1 Q. **Reference: *Structural Capacity Assessment of the Labrador Island Transmission Link (LITL)*,**
2 **EFLA, April 28, 2020, page 23.**

15 **Modified Stiffness of Elements**

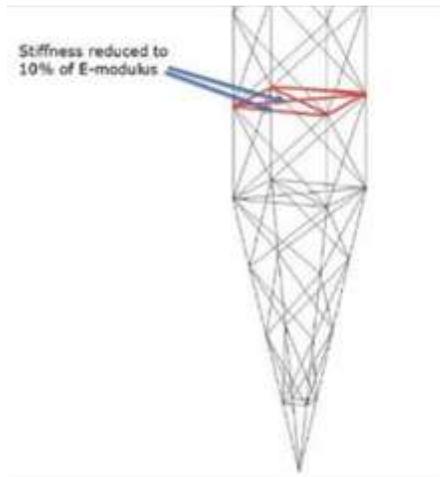
5 Please explain the reasoning for EFLA to make changes to the PLS-CADD and PLS-Tower files, as
6 described on the bottom of page 23 and the top of page 24 of the EFLA report, when a review of
7 tower models, tower detailing and tower design were not part of the scope for the EFLA study.

16 The stiffness of the red elements in the figure below were reduced by a factor of ten in towers
17 128, 282, 286, 288, 1225, 1324 and 1687. The reduction in stiffness can be likened to removing
18 the members altogether. The diagonals directly below the red elements had unrealistically high
19 utilization before modifications of the models. The results were deemed unrealistic as a small
20 increase in load resulted in a very high increase in utilization. With the reduction in stiffness, the
21 tower still has sufficient capacity to support the applied load. This modelling problem/issue is
22 known when using linear Finite Element programs for tower analysis. EFLA Consulting Engineers
23 has used this approach of reducing the element stiffness to overcome the modelling issue in
24 many designs.
